SUBJECT: Calvert Cliffs Nuclear Power Plant
Unit Nos. 1 & 2; Docket Nos. 50-317 & 50-318
License Amendment Request: Revision to Technical Specification P-T Curves

The proposed amendment revises the Unit 1 and Unit 2 cooldown curves [Technical Specification Figure 3.4.3-2 (2 pages)] to change the range of temperatures for which a cooldown rate of 100°F/hr is acceptable.

Figure 3.4.3-2
Calvert Cliffs Unit 1 Cooldown Curve, for Fluence $\leq 4.49 \times 10^{19}$ n/cm²
Reactor Coolant System Pressure Temperature Limits

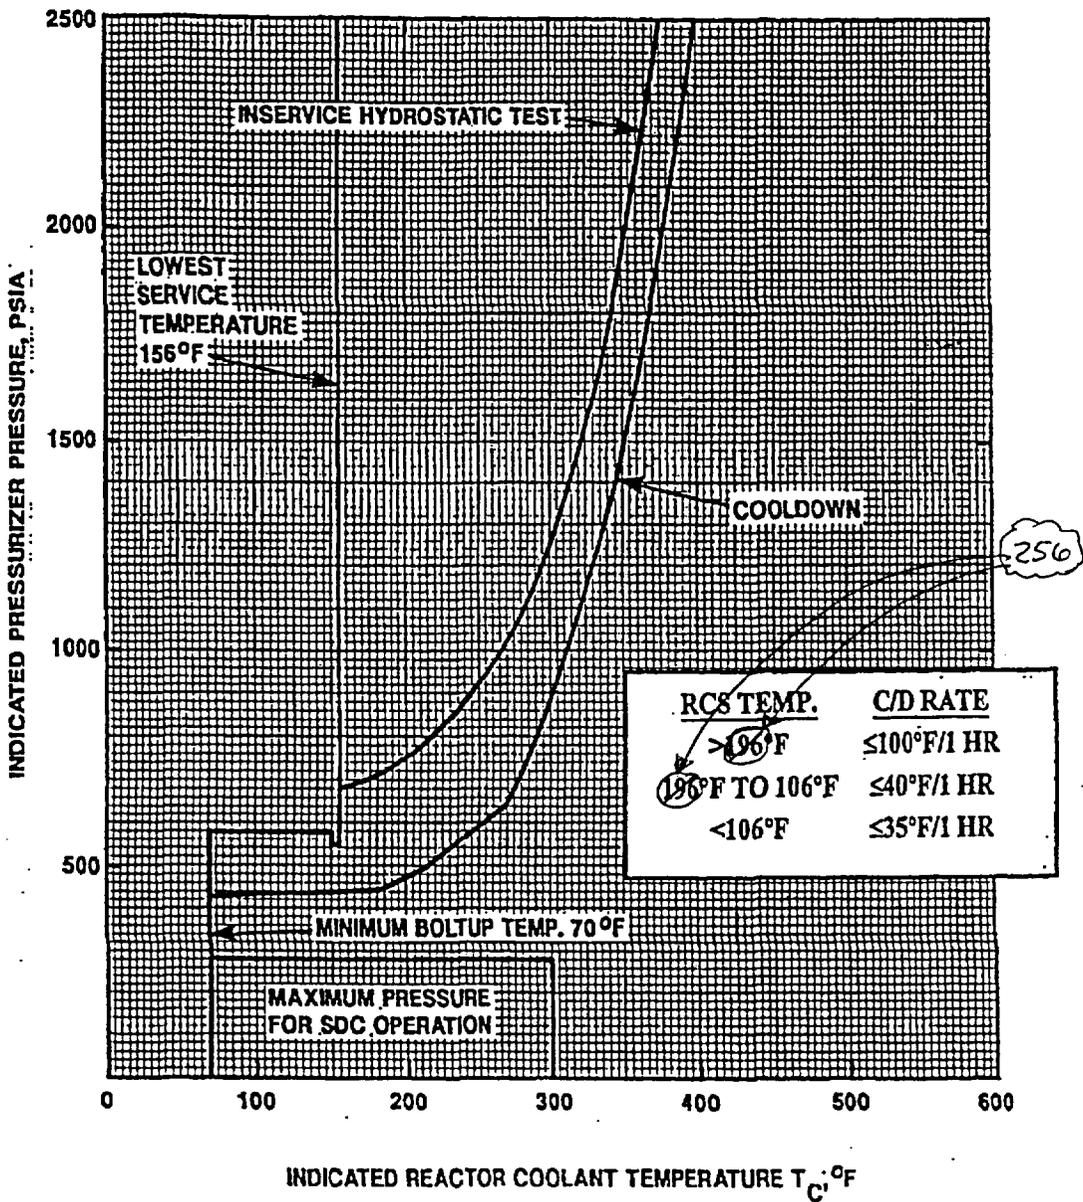
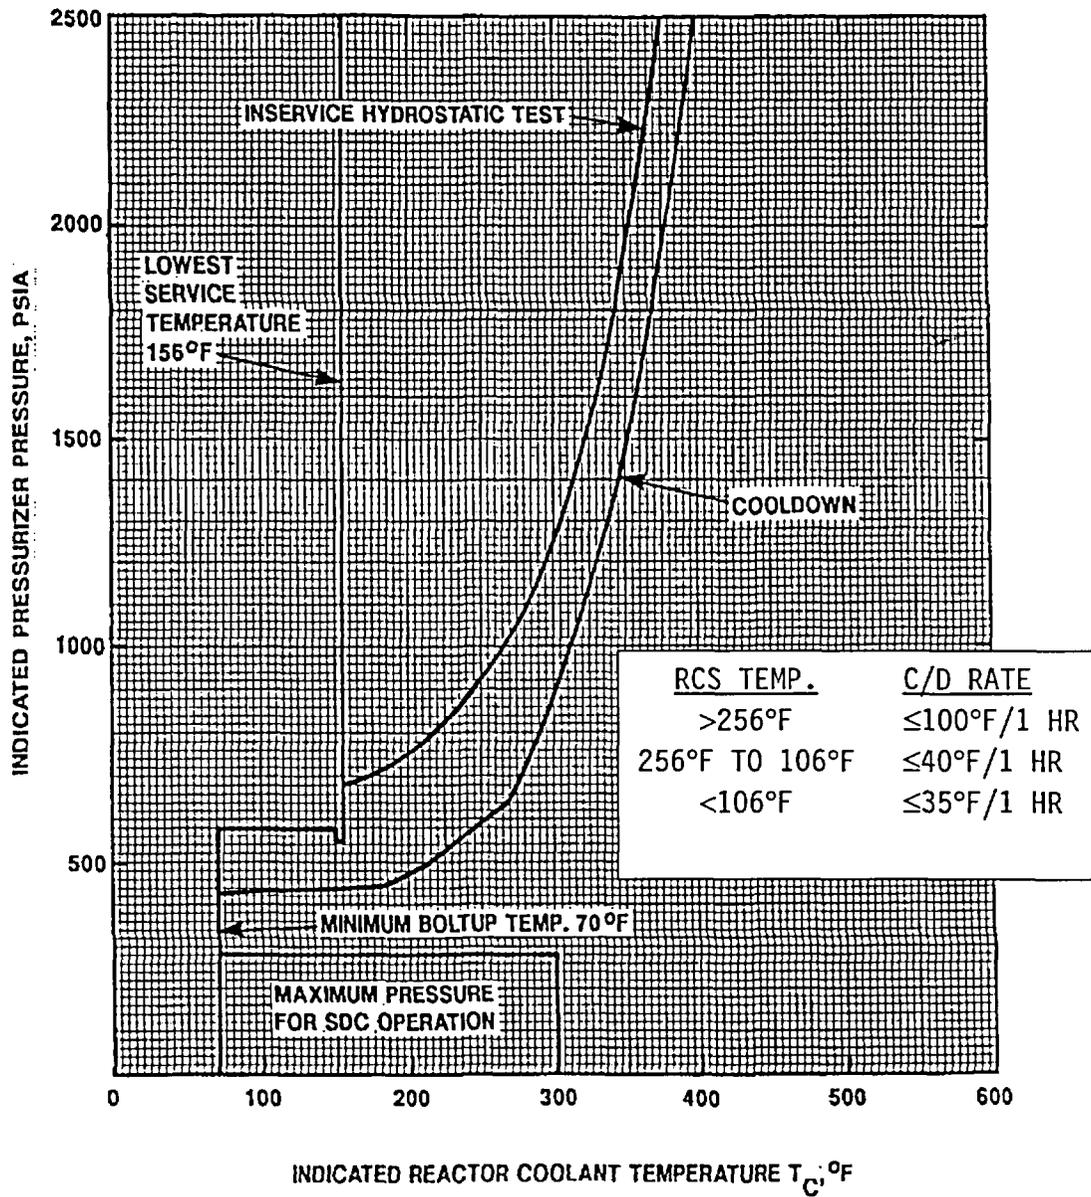
Revise Technical Specification Figures 3.4.3-2 (Unit 1) and 3.4.3-2 (Unit 2) as shown in the marked-up Technical Specification pages in Attachment (1). The final Technical Specification pages are provided in Attachment (2).

This proposed amendment revises the Unit 1 and Unit 2 cooldown curves to change the range of temperatures for which a cooldown rate of 100°F/hr is acceptable. The change in range resulted from an evaluation of a cooldown in which residual stresses from the 100°F/hr rate affected the stress during the cooldown at the 40°F/hr rate.

The proposed change only changes the temperature at which the cooldown transitions from 100°F/hr to 40°F/hr. It does not change the basic cooldown rates or methods of cooling down the Reactor Coolant System. This cooldown transition does not affect the probability of an accident previously evaluated because the cooldown rates have not changed. Additionally, since the cooldown rates are not changed above 300°F, the safety analyses and dose consequences in the Updated Final Safety Analysis Report are not affected.
